HERITAGE BAPTIST CHURCH ADDITION

RE: SUB 2002-50 -- Final Plat of Heritage Baptist Addition

STAFF REPORT
(FINAL PLAT APPROVED 7/18/02; PRELIMINARY PLAT APPROVED 6/27/02)

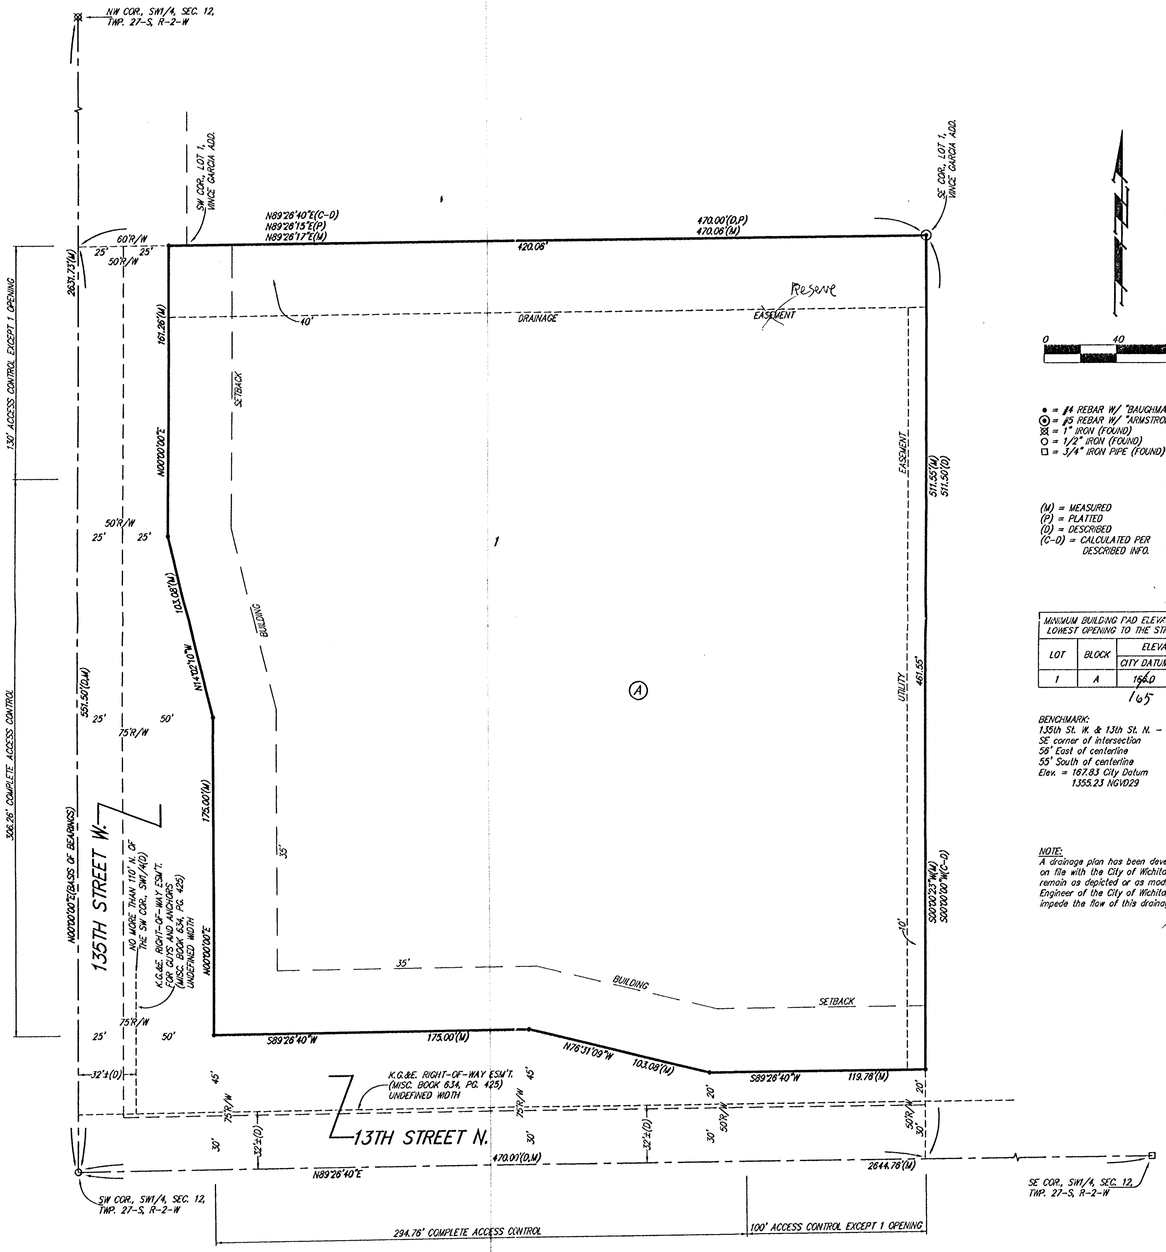
D. County Engineering needs to comment on the status of the applicant's drainage plan. ***The drainage reserve along the north line may be adjusted to line up with the final drainage plan.***

E. The plat proposes one access opening along 13th St. North and one access opening along 135th St. West. ***County Engineering has approved the access controls. The plattor's text shall delete "City of Wichita" and reference the "appropriate governing body".***

G. The plattor's text shall include language that a drainage plan has been developed for the plat and that all drainage easements, rights-of-way, or reserves shall remain at established grades or as modified with the approval of the applicable City or County Engineer, and unobstructed to allow for the conveyance of stormwater.
